Airworthiness Directive

AD No.: 2021-0044

ATA 24 – Electrical Power – Overhead Panel – Inspection

N° 139-661

Figure 1

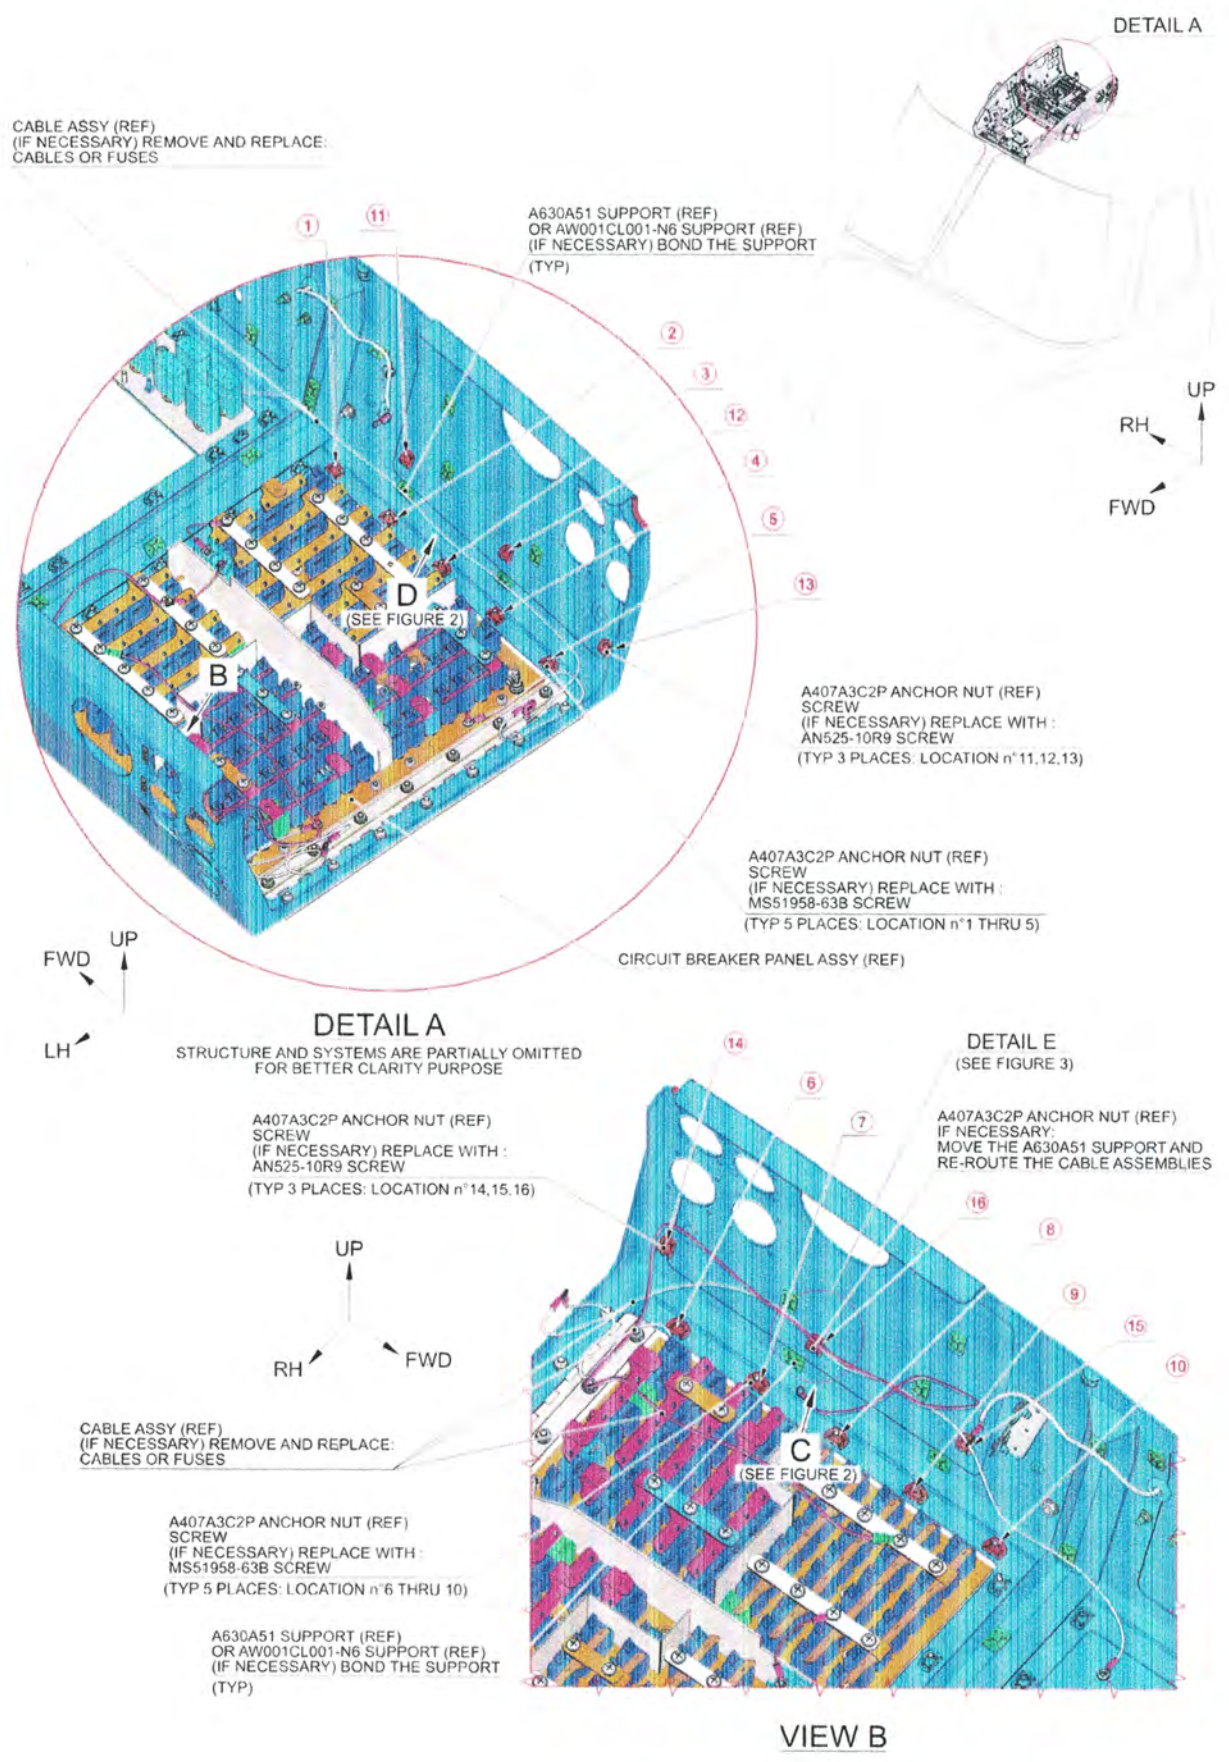
- 2.3 With reference to Figure 1 Detail A and View B, check the length of the screws (removed in the previous step 2.1) at the indicated locations from n°11 thru n°16, if applicable:
 - 2.3.1 Make sure that each screw is long 15.06 mm or less.

- 2.3.2 If the length is not less than 15.06 mm replace each affected screw with a new one P/N AN525-10R9.
- 2.4 With reference to Figure 1 Detail A and View B, remove the screws at the indicated locations from n°1 thru n°10 and check their length:
 - 2.4.1 Make sure that each screw is long 12.7 mm or less.

- 2.4.2 If the length is not less than 12.7 mm replace each affected screw with a new one P/N MS51958-63B.
- 2.5 With reference to Figure 1 Detail A and View B, re-install n°6 screws, if applicable, in their respective anchor nuts P/N A407A3C2P at the indicated locations from n°11 thru n°16 without the lining panels previously removed at step 2.1
- 2.6 With reference to Figure 1 Detail A and View B, re-install n°10 screws in their respective anchor nuts P/N A407A3C2P at the indicated locations from n°1 thru n°10, keeping the circuit breaker panel assy open.
- 2.7 With reference to Figure 1 Detail A and View B, check for chafing damage of the cable harness and ensure that clearance exists between the cable harness and the anchor nuts P/N A407A3C2P and/or the screws at the indicated locations from n°1 thru n°16.

- 2.8 With reference to Figure 1 Detail A and View B, remove and replace the damaged cables or fuses.
- 2.9 With reference to Figure 1 View B and to Figure 3 Detail E, measure at the indicated location n°16, on the LH side, the clearance between the anchor nut P/N A407A3C2P and the cable harnesses including a check of the mutual position.

- 2.10 With reference to Figure 1 View B, move the existing support P/N A630A51 or P/N AW001CL001-N6, as applicable, and re-route the cable harnesses in order to respect the clearance of at least 10.0 mm and guarantee the installation ABOVE the anchor nut.
- 2.11 With reference to Figure 1 Detail A and View B, check that all the supports P/N A630A51 and P/N AW001CL001-N6, as applicable, on the LH and RH side are soundly bonded to the panel with no evidences of detachment or delamination.

Figure 2

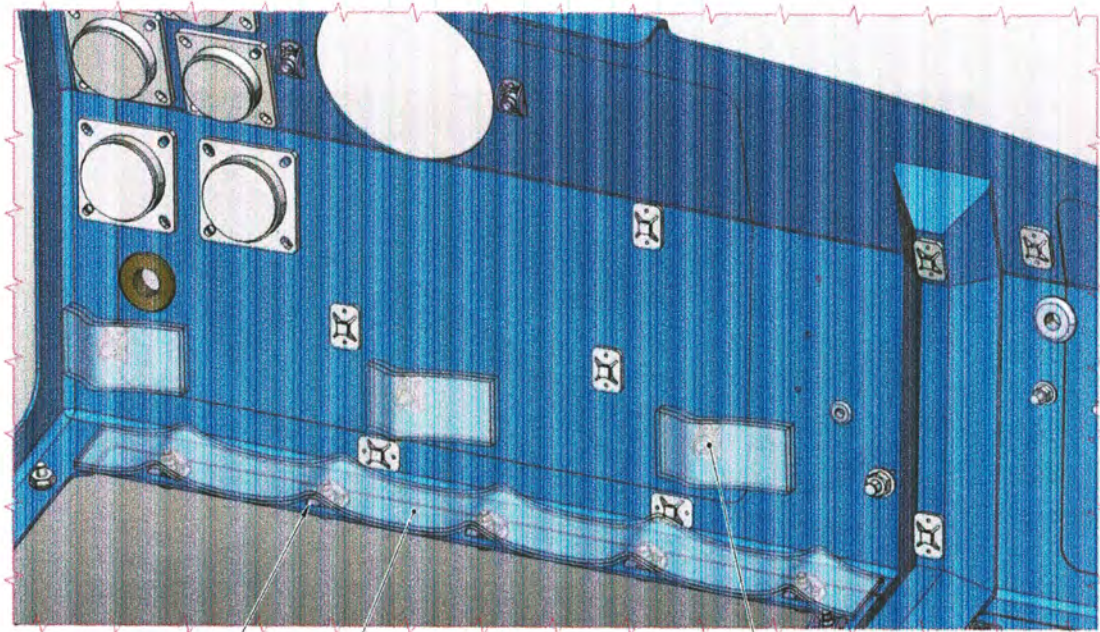
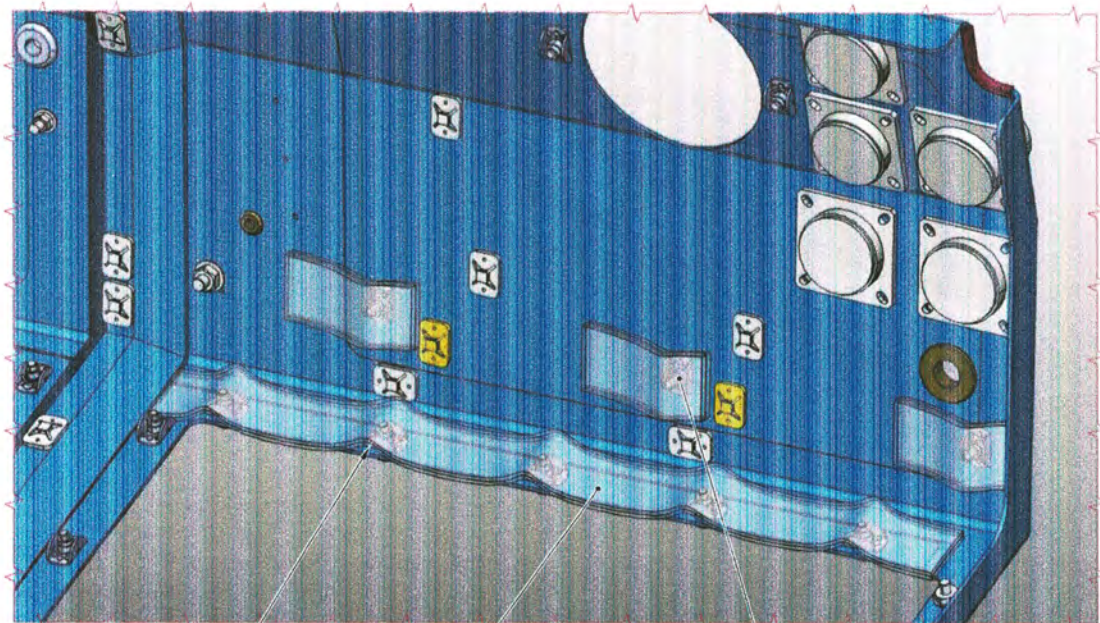
- 2.13 With reference to Figure 1 Detail A and View B, to Figure 2 View C and View D, apply n°2 layers of the white tape P/N AW005ME04T05305 on n°10 anchor nuts P/N A407A3C2P (n°5 on the LH side and n°5 on the RH side).
- 2.14 With reference to Figure 1 Detail A and View B, to Figure 2 View C and View D, apply n°2 layers of the white tape P/N AW005ME04T05305 on each of the n°6

- 2.3 With reference to Figure 1 Detail A and View B, to Figure 2 View C and View D, check for the condition of the n°2 layers of the white tape P/N AW005ME04T05305 on n°10 anchor nuts P/N A407A3C2P (n°5 on the LH side and n°5 on the RH side).

- 2.4 With reference Figure 2 View C, remove n°2 layers of the white tape from the anchor nuts and apply in the same position n°2 new layers of the white tape P/N AW005ME04T05305.

- 2.5 With reference to Figure 2 View D, repeat step 2.4 for the RH side.
- 2.6 With reference to Figure 1 Detail A and View B, to Figure 2 View C and View D, check for the condition of the n°2 layers of the white tape P/N AW005ME04T05305 on each of the n°6 anchor nuts P/N A407A3C2P (n°3 on the LH side and n°3 on the RH side).

Figure 3

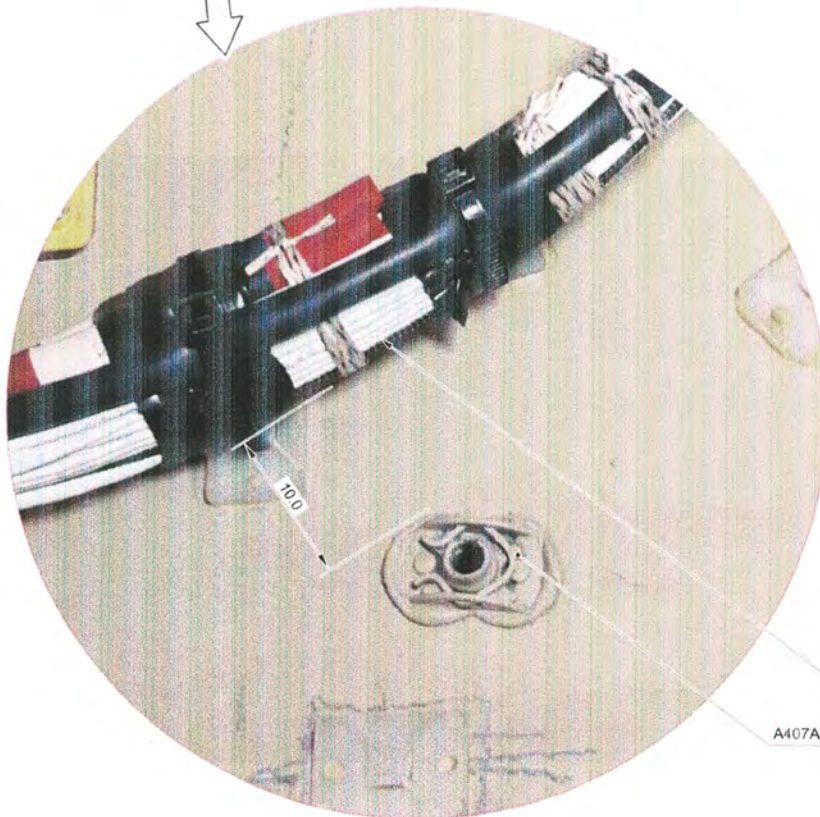
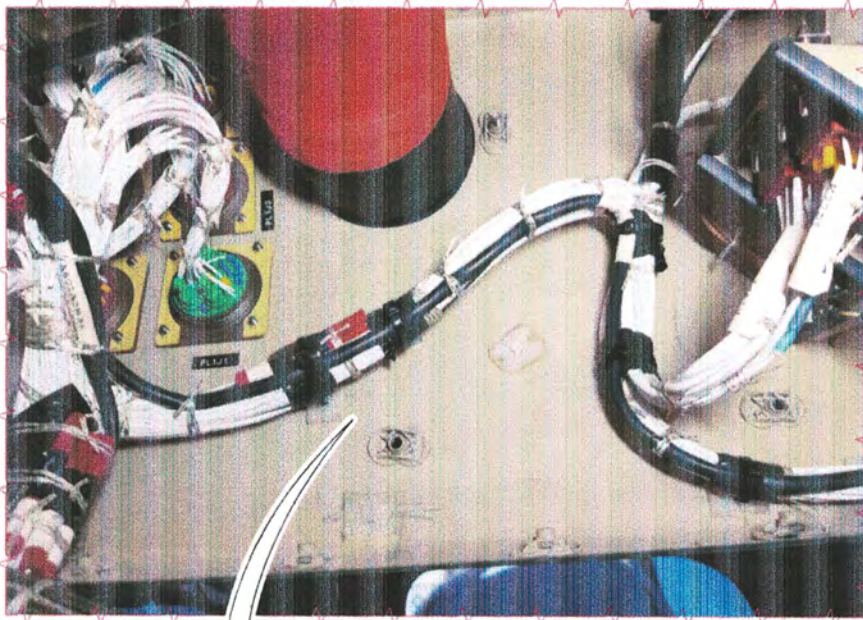
Perform the following step 2.10 if the clearance is NOT at least 10.0 mm and/or if the cable harnesses is installed BELOW the anchor nut.
